Office Action Summary

10/580,379

BACON, RAYMOND JOHN

DETAILED ACTION

Fig. 2 of Brunet as annotated by examiner

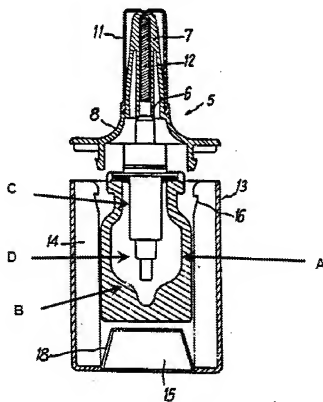
Brunet shows a dispenser for a gaseous, gas borne or droplet substance comprising a source (2) of the substance, wherein the substance comprises medicament and propellant (Col. 1, ll. 7-20) and the source comprises a reservoir (2) and a release valve (3). The reservoir comprises: a major portion (A in examiner annotated figure below) having a comparatively large cross-section of its substance space and a minor portion (B in examiner annotated figure below) in the form of a tapered tip having a comparatively small cross-section of its substance space and at the opposite end of the source from the release valve (Fig. 1).

Regarding claim 3, Brunet shows that the minor portion (B in examiner annotated figure below) of the reservoir has a progressively diminishing cross section whereby the rate of fall of the level of substance increases as it is further depleted (inherent effect from diminishing cross section).

Regarding claims 11, 13 and 14, Brunet shows that the reservoir is provided with an insert (C, D in examiner annotated figure below) which substantially reduces the cross-section thereof, includes a uniform cross section (C in examiner annotated figure below has constant cross section) and is tapered (D in examiner annotated figure below tapers).
